Metropolitan Planning Commission

Staff Reports

May 10, 2012

2010SP-022-003 CARMAX RIVERGATE Map 026-12, Parcel(s) 006, 007 Madison 10 - Doug Pardue

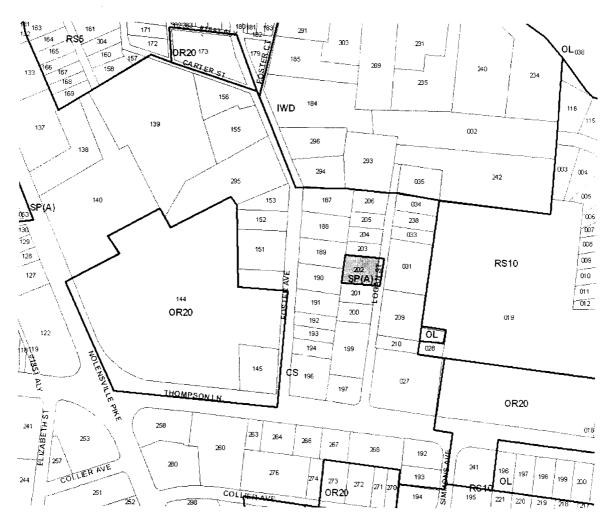
- 1. Provide the Grading Permit fee of \$875. Provide maintenance / easement documents, exhibit sheet, and recording fees.
- 2. Add correct parcel identification number to the plan.

- 3. Provide NOC.
- 4. Show more clearly the existing storm infrastructure (onsite and along ROW).
- 5. Show matting proposed on all 3:1 slopes or steeper. Also add a matting detail.

- 6. Provide more TOW / BOW elevations (for the wall next to the staging area).
- 7. The Hydraflow Plan View does not match the storm layout for the pond / road network. Also, the runoff coefficients appear low.

- 8. Provide more information for the Gallatin Pike road / storm system (spread for Gallatin, how existing ditches and pipes are being accounted for, etc.). While spread may be less than 8', it is still suggested to add inlets.

- 9. Why is bypass flows shown for inlet 7?
- 10. For the detention pond calculations, post hydrographs, routed hydrographs, and pond report information was not observed.

- 11. The water quality pond short circuits. Redesign with greater distances between the headwall and the outlet structure.
- 12. For the Rv calculation, the impervious percentage is low. Provide a breakdown.

- 13. H-Ho based on the detail looks to be 2.25', not 2.4'.
- 14. Add a grate to the top of the outlet structure.
